AIR - PROVIDE HPT ACC TUBES WITH IMPROVED MAINTAINABILITY FEATURES - CATEGORY CODE 7 -
MOD.ENG-75-0013

V2500-ENG-75-0013

**SERVICE BULLETIN**

Installation of 2A1561 R/H Turbine Cooling Manifold Assembly, 2A1562 L/H Turbine Cooling manifold Assembly, and 2A1540 or 2A1569 Turbine Cooling Manifold
Fig.7 (Sheet 1 of 2)

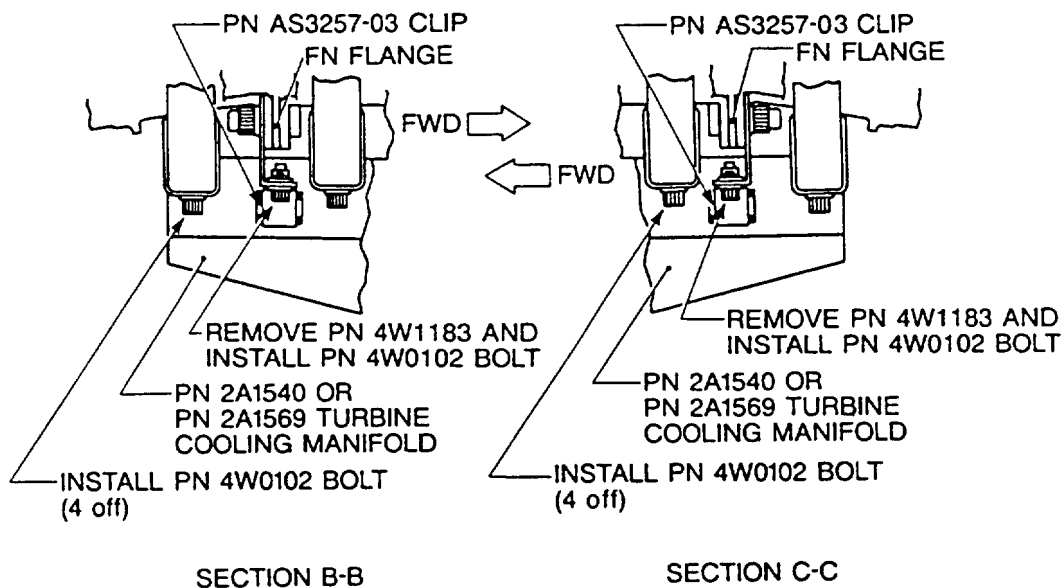
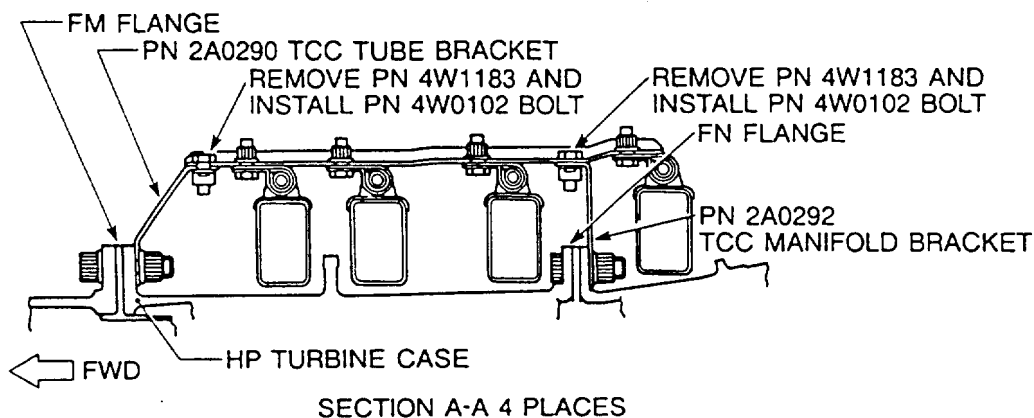
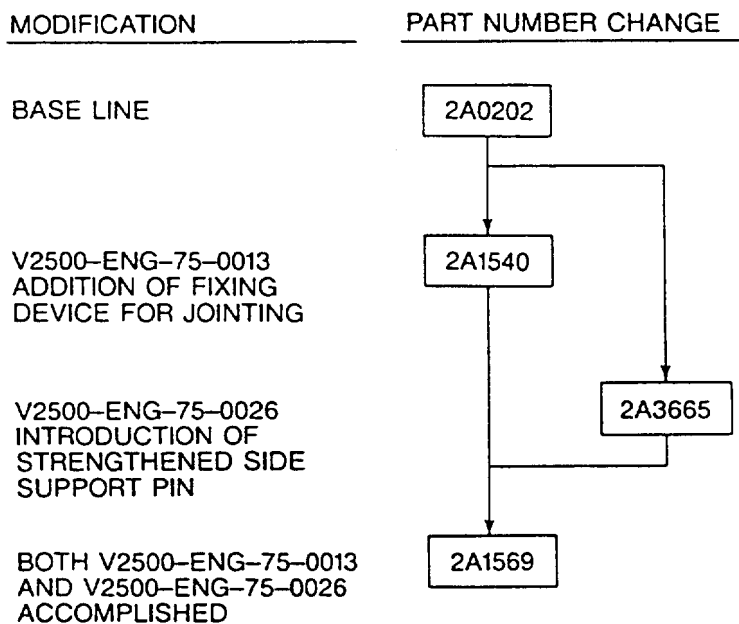
- (c) Install the Turbine Cooling Manifold to the engine. Refer to Figure 7.
- (i) Install two AS3257-03 Clips to 2A1540 or 2A1569 Turbine Cooling Manifold.

- NOTE: Make sure the direction of Clips is correct.
- (ii) Lubricate threads of two 4W0471 Bolts with CoMat 10-077 approved engine oils. Install the Turbine Cooling Manifold to the FM flange with the Bolts and 4W0003 Nuts.

- (iii) Torque the Nuts to 180 to 200 lbfin (20,34 to 22,59 Nm).
- (iv) Lubricate threads of two 4W0102 Bolts with CoMat 10-077 approved engine oils. Install the Clips on the Turbine Cooling Manifold to the 2A1581 and 2A1579 TCC Manifold Brackets on FN flange with the Bolts.

- (v) Torque the Bolts to 36 to 40 lbfin (4,00 to 4,52 Nm).
- (d) Install the R/H Turbine Cooling Manifold Assembly to the engine. Refer to Figure 7.
- (i) Insert tube ends of 2A1561 R/H Turbine Cooling Manifold Assembly to the turbine Cooling Manifold.

- (ii) Lubricate threads of four 4W0102 Bolts with CoMat 10-077 approved engine oils. Install two Brackets of the R/H Turbine Cooling Manifold to 2A0290 TCC Tube Bracket on FM flange and 2A0292 TCC Manifold Bracket on FN flange with the Bolts. Hand tighten the Bolts.

- (iii) Lubricate threads of four 4W0102 Bolts with CoMat 10-077 approved engine oils. Fix the connection of the Turbine Cooling Manifold and the R/H Turbine Cooling Manifold Assembly with the bolts. Torque the Bolts to 36 to 40 lbfin (4,00 to 4,52 Nm).
